SS 723-WST 2022 49X Hood Handle Mounting

49X vehicles

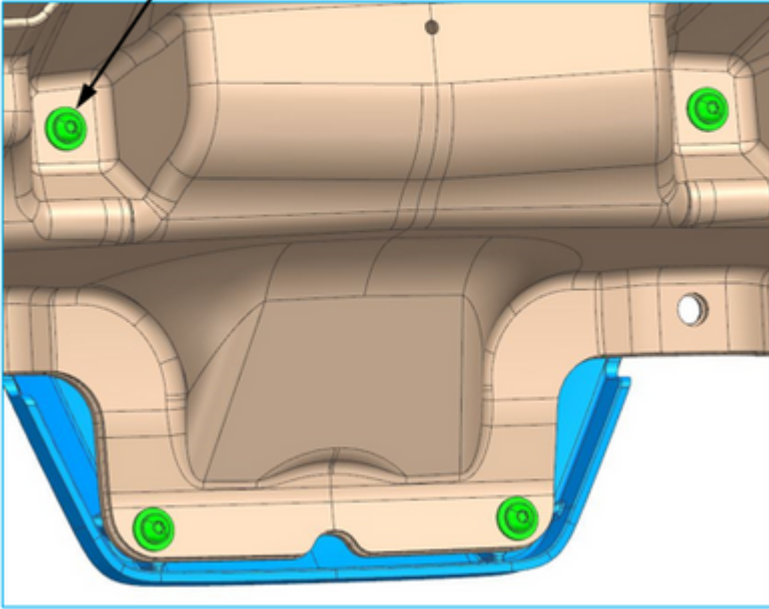
Hood handle mounting studs on the front of the hood may contact radiator mounted grille.

Stud length on hood handle may contact grille on certain installations.

Open hood, remove hood handle stud installations (quantity 4) and replace with part below:

23-13602-025 SCR,RND WSHRHD,HX RECSS,M6X1.0 (4)

Torq fasteners to 4.6ft/lb

4X 23-13602-025
M6 Capscrew w/Washer
